STATE OF ALASKA
LIBRARY ARCHIVES MUSEUM

Submittal #: 06 41 00-6.1

Specification: 06 41 00 Architectural Wood Casework

Description: Gift Shop Casework Shop Drawings

2 EAST ELEVATION - REGISTER CASEWORK
1/2" = 1'-0"

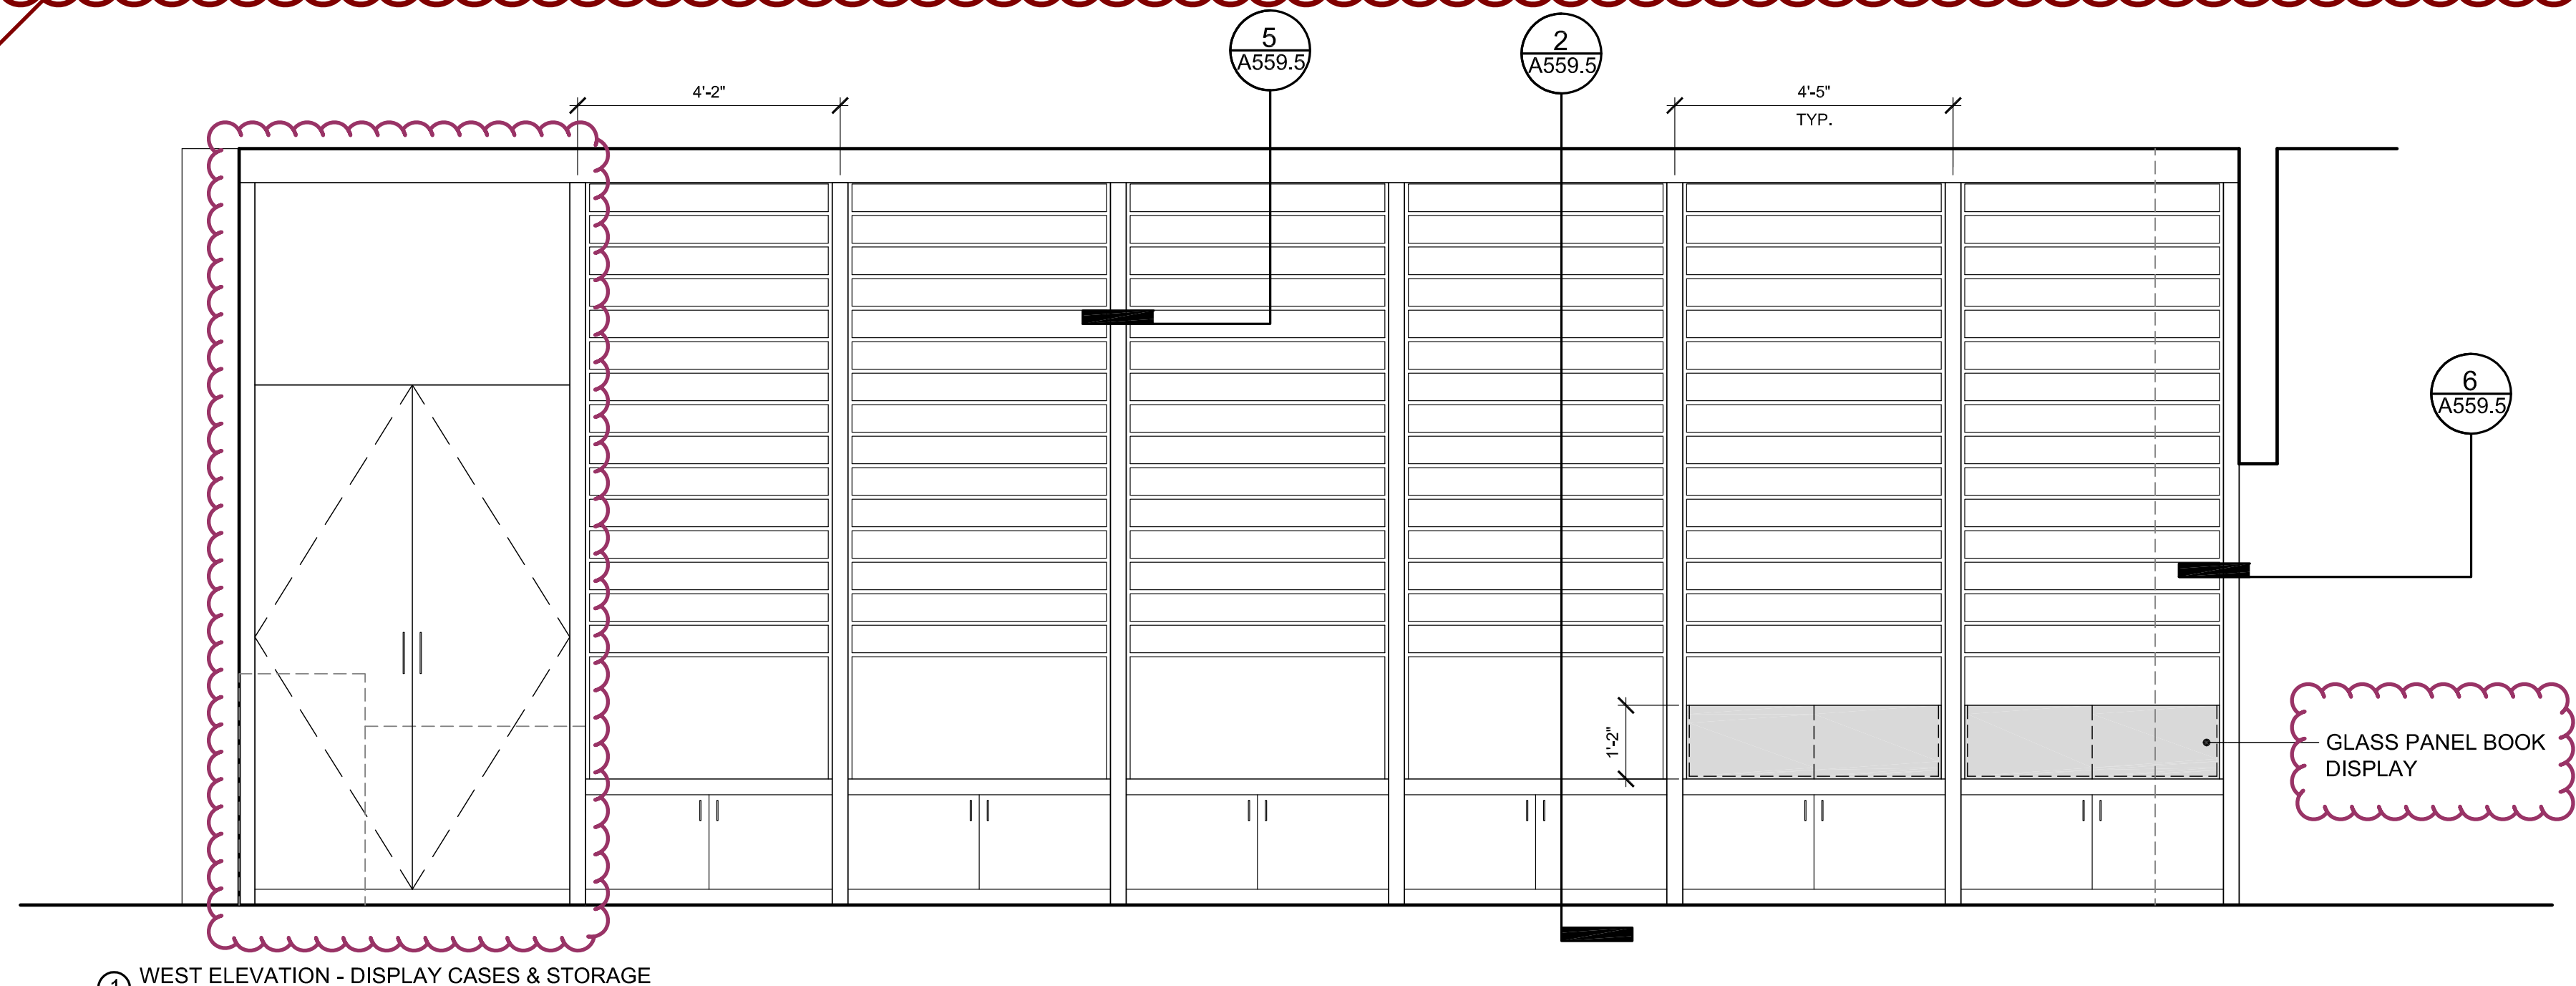
RFI# 1096

8/27/15- door is designed to have behind gift shop register for storage. Door hardware per RFI for Bi fold doors.

RFI# 1085

8/27/15- See RFI sketch SK-RFI1085-1 for details on glass panel book displays.

8 EAST ELEVATION - DISPLAY CASES & STORAGE
1/2" = 1'-0"

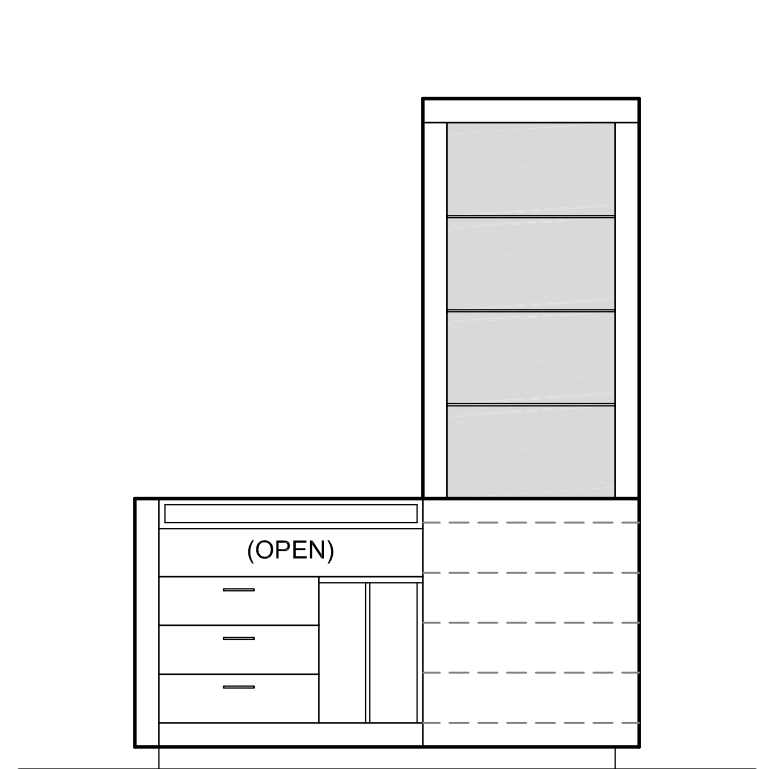
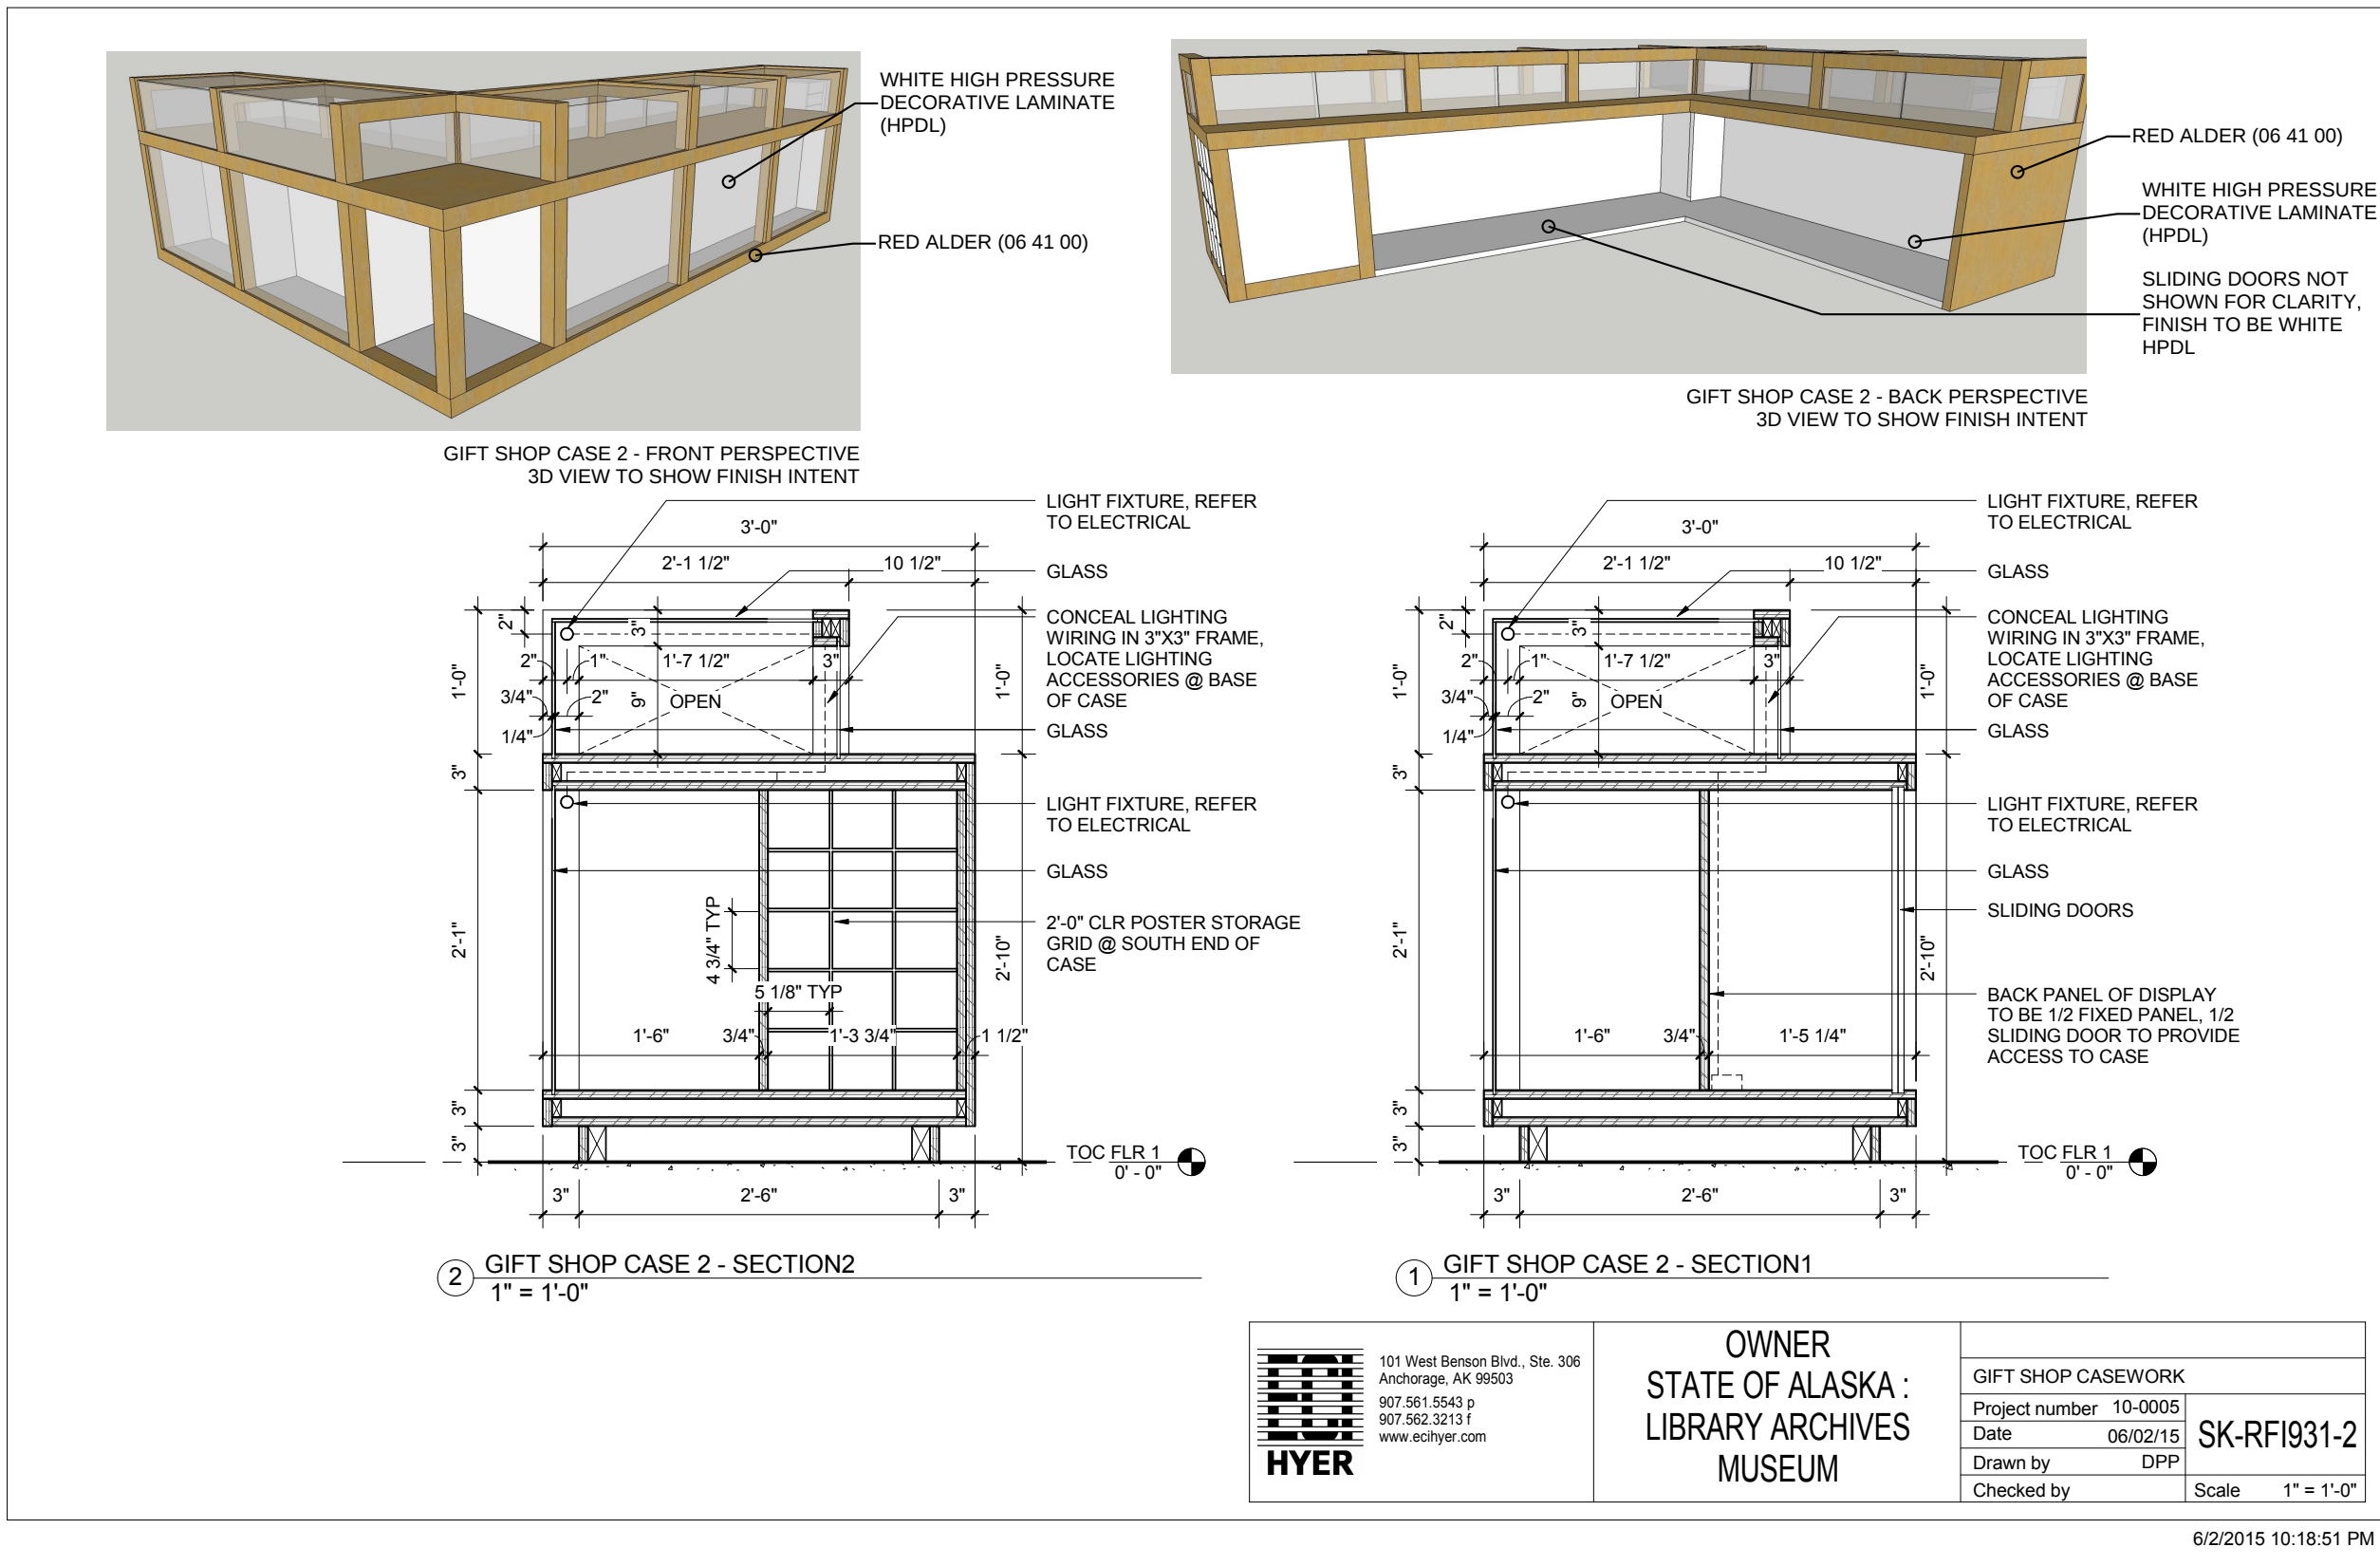
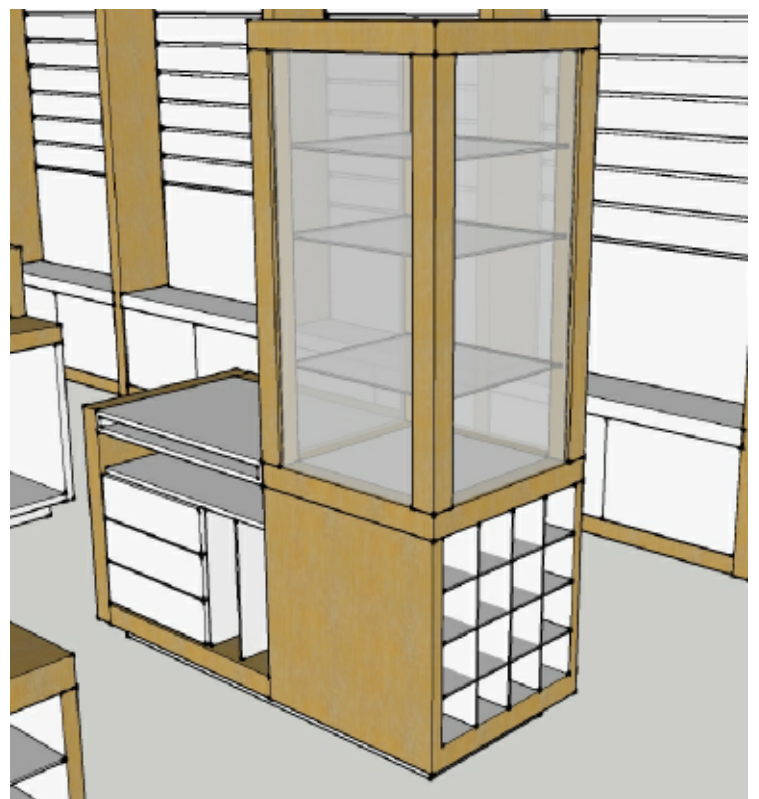
6/3/15 - SEE
ATTACHED SKETCH
SK-RF1931-3 AND 2
FOR ADDITIONAL
FINISH
CLARIFICATIONS
AND SECTION
VIEWS.

CASEWORK
DETAILS

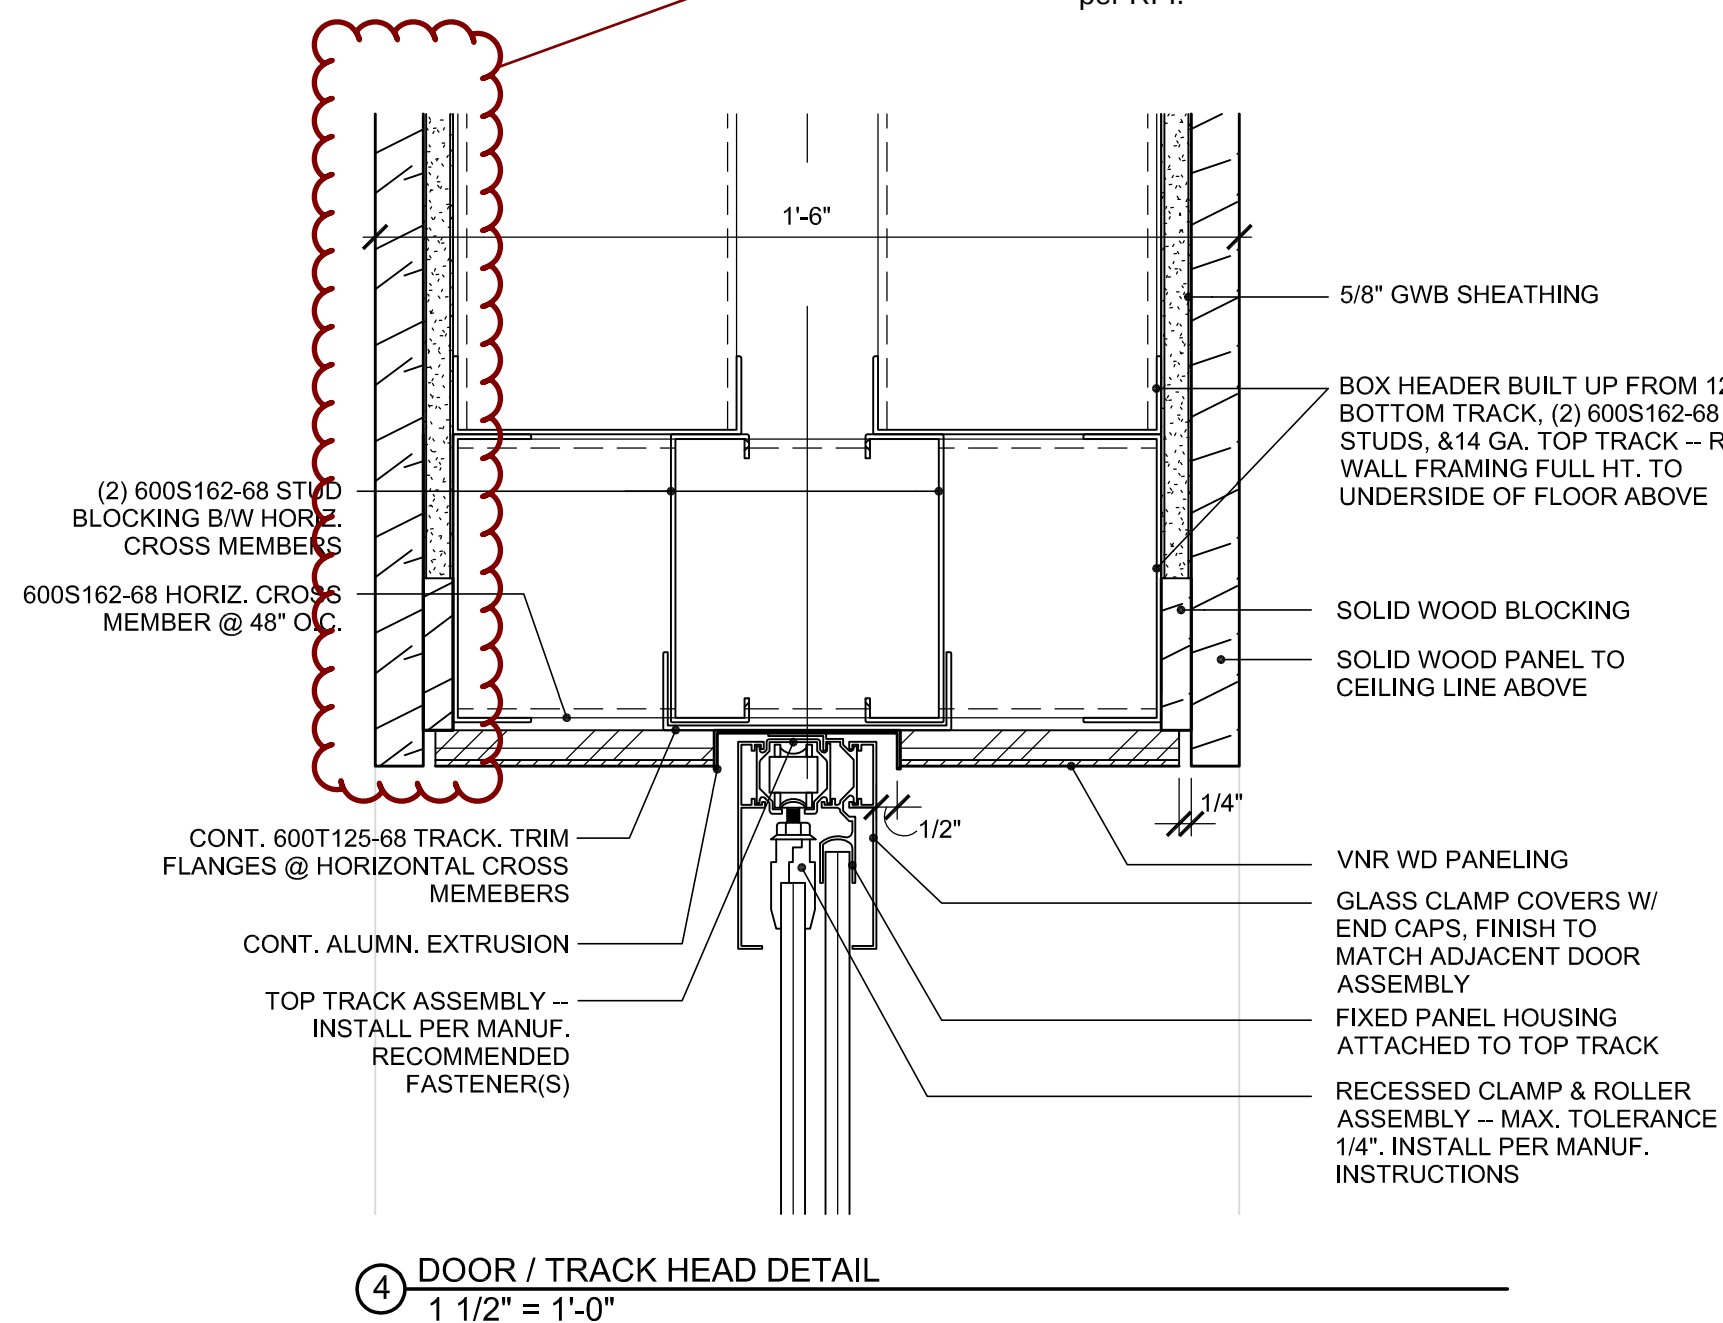
8/28/15- ceiling is to have 1" gap between face of trim and wd trim. Add GWB as needed to flush out with column beyond and face of wd trim. GWB above trim painted P-1.

8/24/15- add soffits to east and south wall in gift shop to support this detail.

④ DOOR / TRACK HEAD DETAIL
1 1/2" = 1'-0"

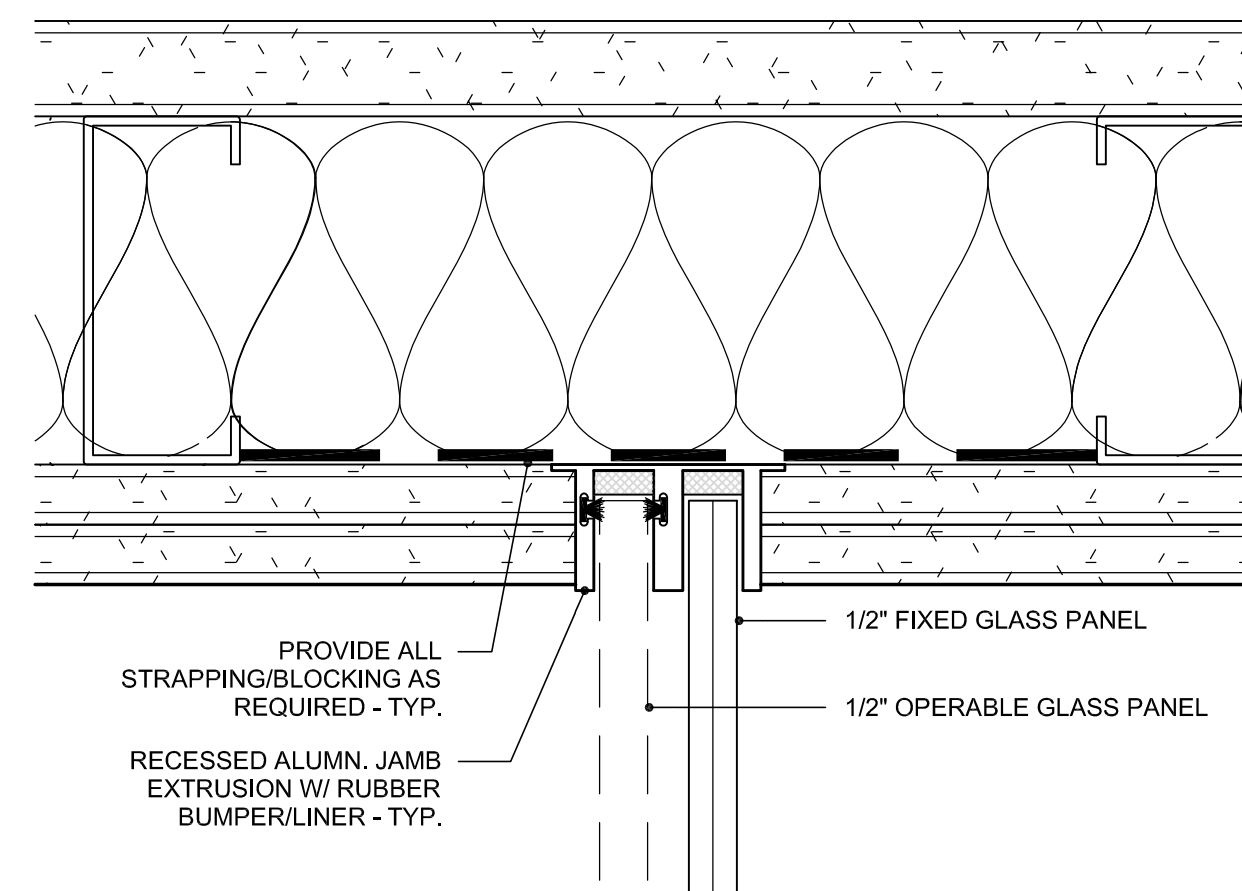
4/2/15 - At museum side
(left side) replace solid
wood panel with GL-11
per RFI.
